Comments of the Referee#3.

Reply to the comments of the Referee#3:

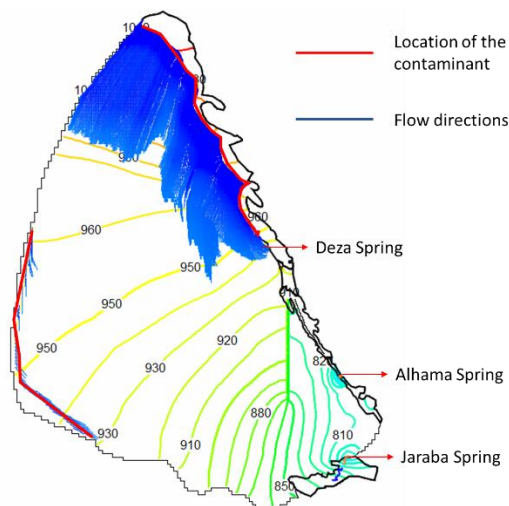
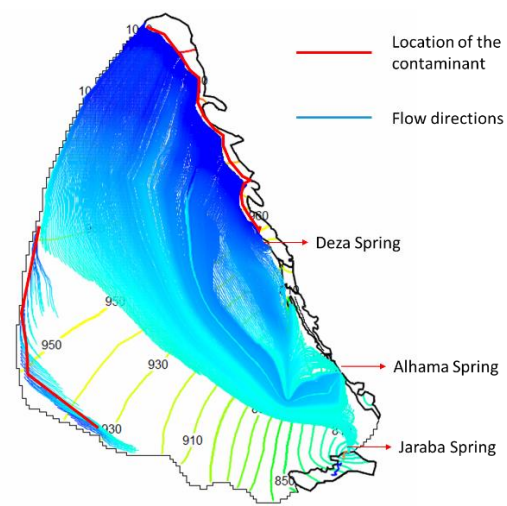
1. The biggest problem is that the author didn't well leverage the model they built. If the objective is to identify the source of the springs, after you built the well calibrated flow model and did particle tracking using MODPATH based on your flow field, why not analyze the flow paths of the particle tracking results. Then you can easily get what you want and then the modeling work is essentially meaningful.

3. If the author can utilize the model well, the last part of hydrochemisty is not necessary. You can merge them into your analyzation of your particle tracking results and use these data to validate your particle tracking results. In Lines 859 and 861, it is sad to see 'is assumed' as you still cannot identity the flow paths after si many modeling efforts.

Thank you very much for these observations that we consider important. The MODPATH was actually used at the time but we thought that in order not to accumulate an excessive number of figures in the article, it was finally not included. But we think it's very good to discuss this topic. So, we include the results in section 4.3.9, where it can be seen that the ages obtained from the flow considering the recharge area of the model are compatible with the results of the tritium isotopes for each spring, since they are of the same order of magnitude. We intended to write the following in the section of the article referring to the model (4.3.9.) and in 4.4. I hope they seem good to you:

We can see in figures 1-A and 1-B the progress of said tracer after 20 years and 80 years. It can be seen in Figure 1-A how after around 20-25 years it comes out through the Deza springs. And in Figure 1-B, how after 80 years. It leaves through the springs of Alhama de Aragón first, and then through Jaraba, having made a similar route concentrated in the deepest and most conductive area, although the peripheral flow that flows into Jaraba makes it slightly longer and older. Let us advance here the ages obtained by tritium from the following section, and although these have a semiquantitative and approximate value, we see that the results obtained by the two methods are of the same order of magnitude. Indeed, it is observed that the simulation shows that the waters of the Deza springs are more modern than those of Alhama and Jaraba, and that the age obtained from the model coincides with the time estimated by tritium from the latest analyses, which is about 20-25 years. In the case of Alhama and Jaraba we observe that the ages obtained by tritium from the most recent analyzes give us an age of more than 61 years, so 80 years could fit.

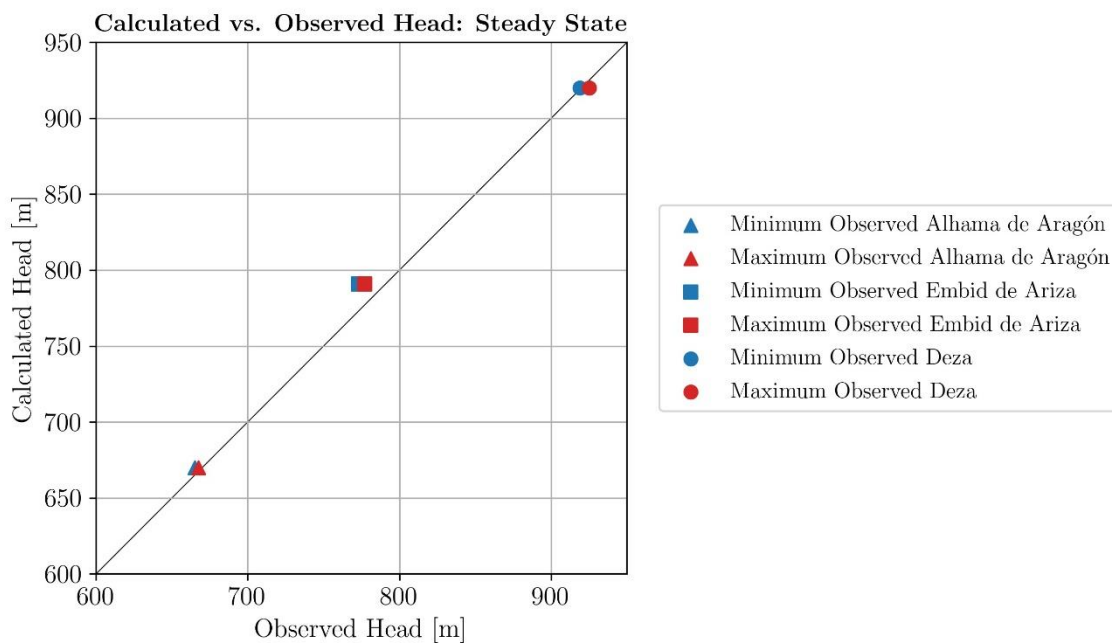
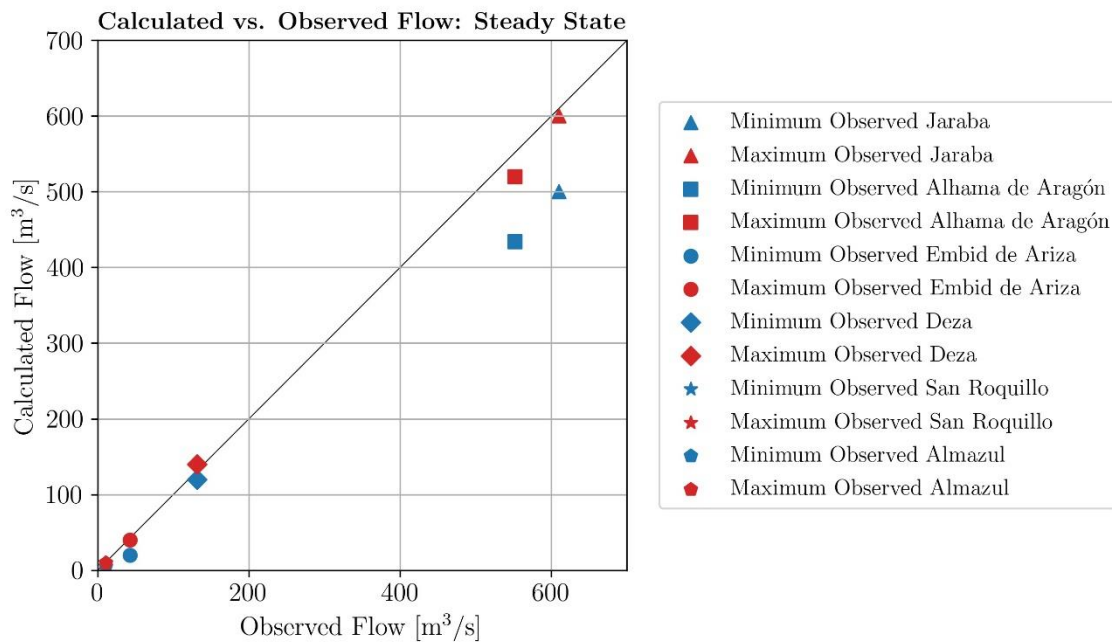
Fig. 18: I don't think the legend is right. The red and blue points are neither observed values nor the simulated values.

The figure shows the maximum and minimum observed values, as shown in the table 2 and table 3. Please check it. I surrounded in a red square the minimum and maximum observed values concerning table 2.

In addition, we have changed the figures slightly so that they can be understood better. I show below the updated figures.
